QUARTER SCALE AUTO CLUB, Inc.

OFFICIAL 2025 QSAC DIRT TRACK RULES ADDENDUM

TOP WING - DIRT TRACK

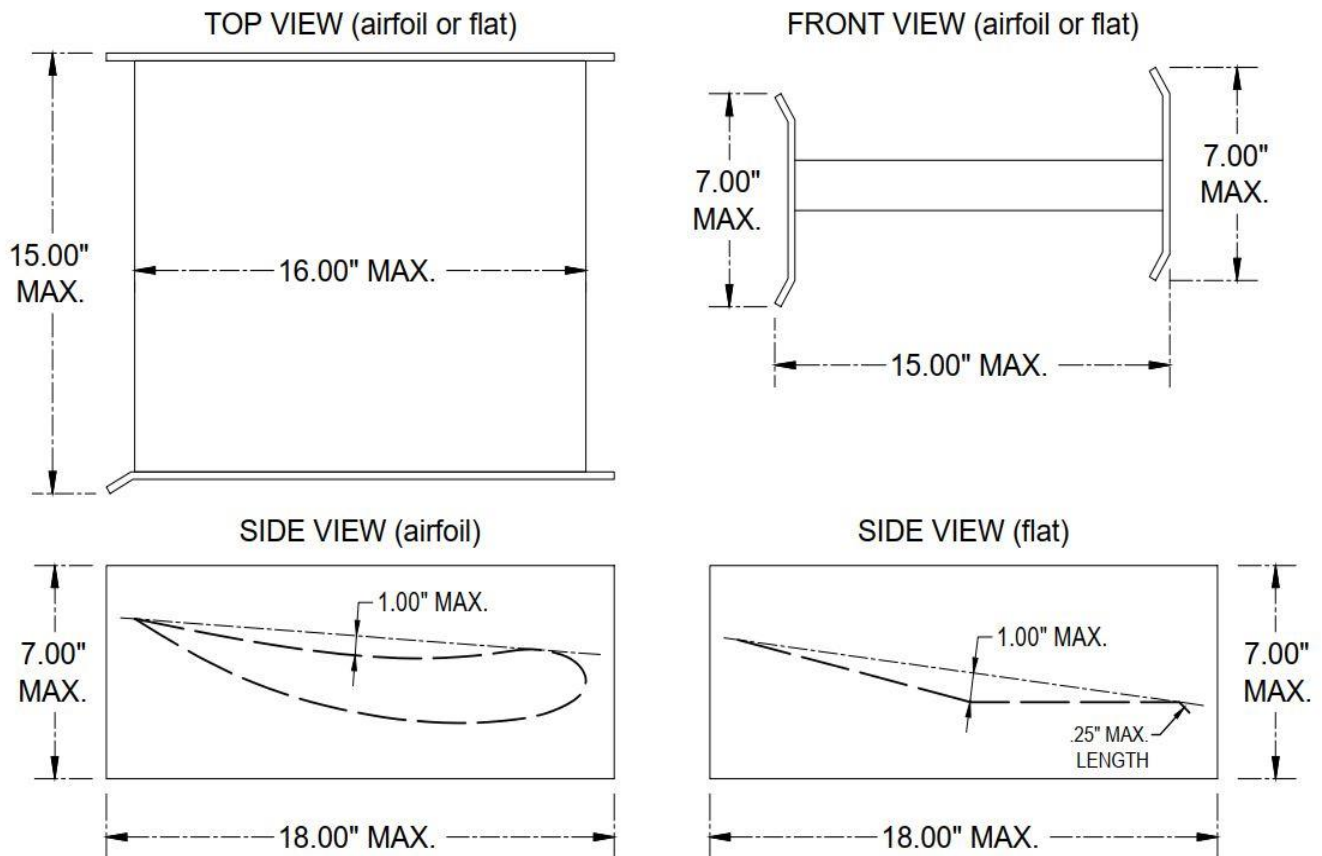
UPDATED/CORRECTED IMAGE TITLED "TOP WING- DIRT TRACK", SPECIFICALLY THE UPPER RIGHT IMAGE TITLED "FRONT VIEW (airfoil or flat)" BY CHANGING THE VALUE FOR THE OVERALL WIDTH FROM "14.00" MAX." TO "15.00" MAX."

REASON FOR THE CHANGE: WHEN THE ORIGINAL IMAGE WAS CREATED, THE SIDE VIEW WAS CORRECTLY LABELED WITH "15.00" MAX.", BUT THE FRONT VIEW HAD BEEN INCORRECTLY LABELED AS "14.00" MAX.". THIS CHANGE MAKES THE TWO IMAGES MATCH ONE ANOTHER AS WELL AS MATCH WHAT IS LISTED IN THE BODY OF THE DOCUMENT.
